Service Bulletin: SB 427-302; Bell 427 Air Conditioner Compressor Drive Belt and Pulley Replacement.

Subject: Up-grade and replacement of the Air Conditioner Compressor Drive Belt and Pulleys.

Date: 3 March, 2005, Rev N/C
28 March, 2005, Rev A

Applicability: Bell Helicopter, 427 Equipped with the Air Comm Corporation Air Conditioner system.

Figure 2.1
 Continued

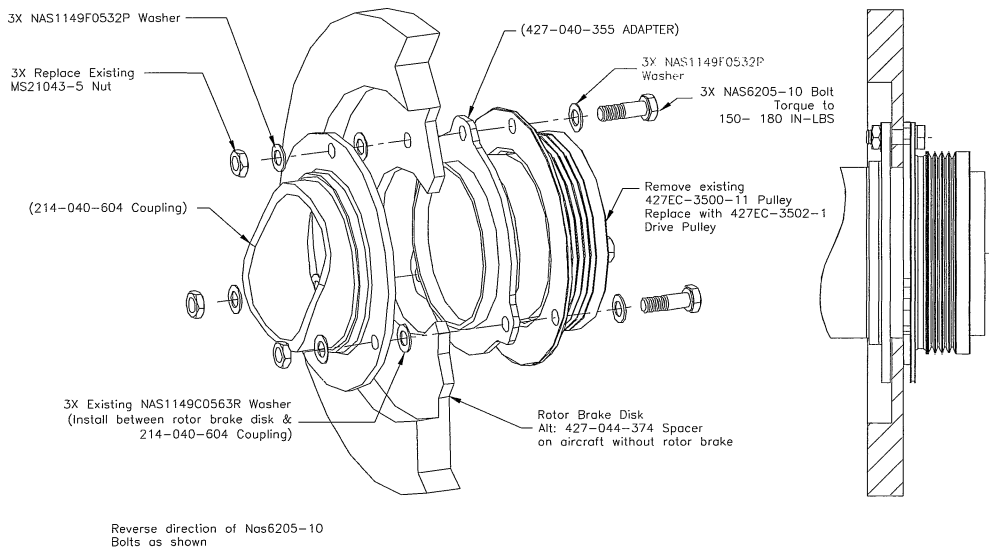
Install the attaching hardware in the 427EC-3502-1 Drive Pulley Assy., NAS6205-10 Bolt (3X), MS21043-5 Nut (3X), NAS1149F0532P Washer (3X), NAS1149C0563R Washer (3X), Torque Nuts to **150 – 180** in lbs. (See figure 2.1)

Please note that the new direction of installation for the NAS6205-10 Bolts as shown in figure 2.1

Figure 2.2

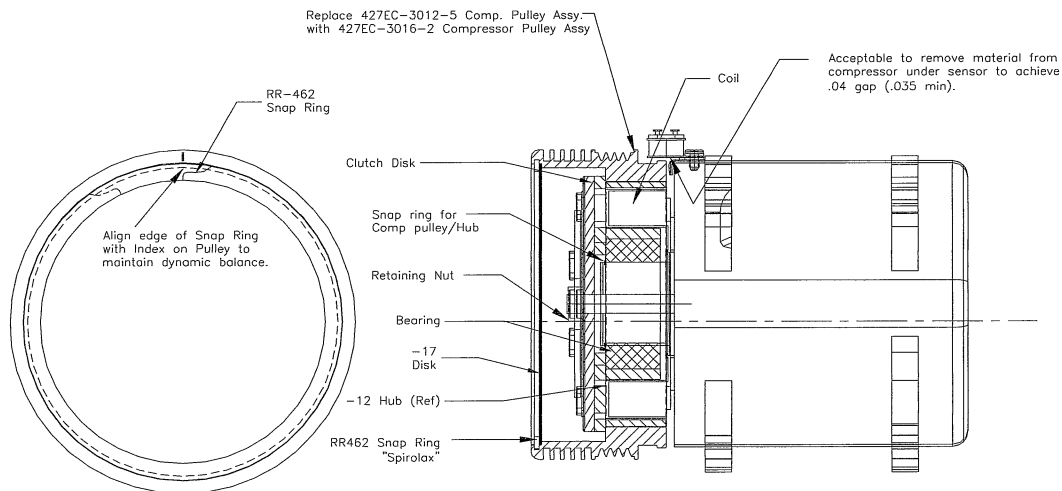
Install RR-426 Snap Ring so that the beveled edge of the ring aligns with the index mark on the outer surface of the new compressor pulley. (See figure 2.2)

Figure 2.3

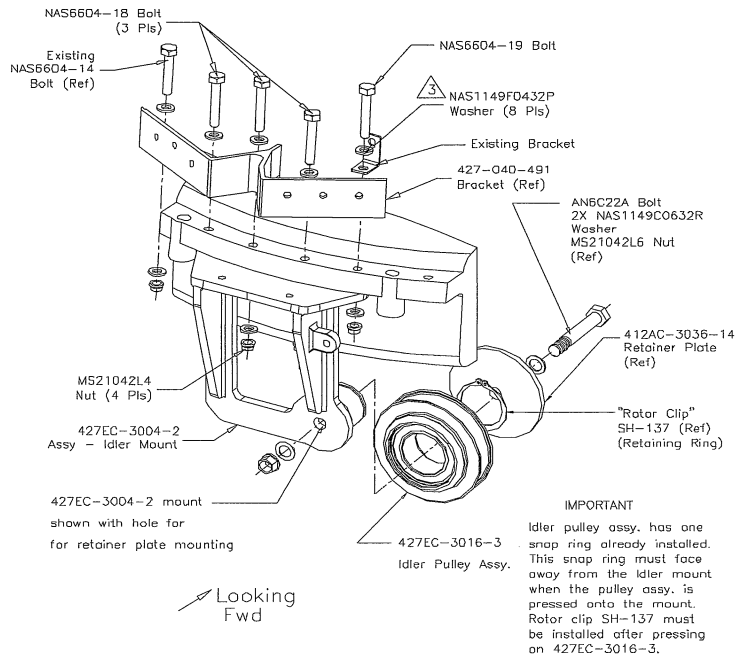
6. Reinstall the AN6C22A Bolt (1X), NAS1149C0632R Washer (2X), MS21042L6 Nut (1X), from the 412AC-3036-14 Retainer Plate to access the 427EC-3500-18 Idler Pulley Assembly. Reinstall SH-137 Rotor Clip to 427EC-3004-2 Idler Mount. Torque Nut **50 -70** in-lbs. (See figure 2.3)

7. Reinstall the NAS6604-18 Bolt (3X), NAS6604-19 Bolt (1X), NAS1149F0432P Washers (8X), MS21042L4 Nut (4X), to reinstall the 427EC-3004-2 Mount Assembly to the transmission housing. Torque Nuts **50 - 70** in-lbs. (See figure 2.3)

Figure 2.4

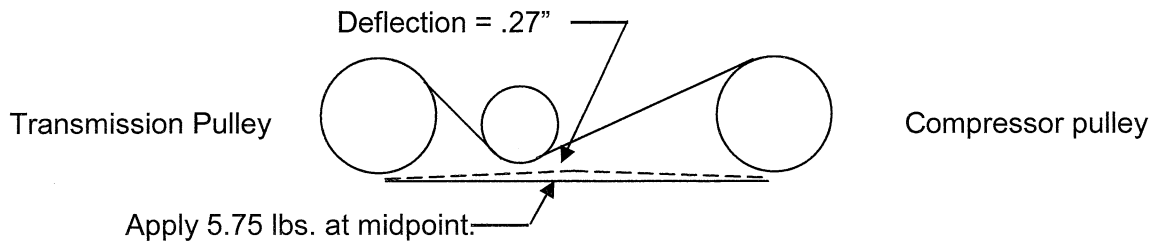
9. Install new ES35427-1 Poly-V Belt on the air conditioner drive pulleys and tension the belt using the 412AC-3012-3 Link Assy. The correct belt tension is achieved when 5.75 lbs. of force at the mid span of the belt produces .27" deflection. (It is recommended that a belt tensioning gauge be used during the installation of this belt. Kent-Moore BT-33-73F or equivalent). (Figure 2.4) (See Page 11 of 11 for use of Belt Tension Tester).
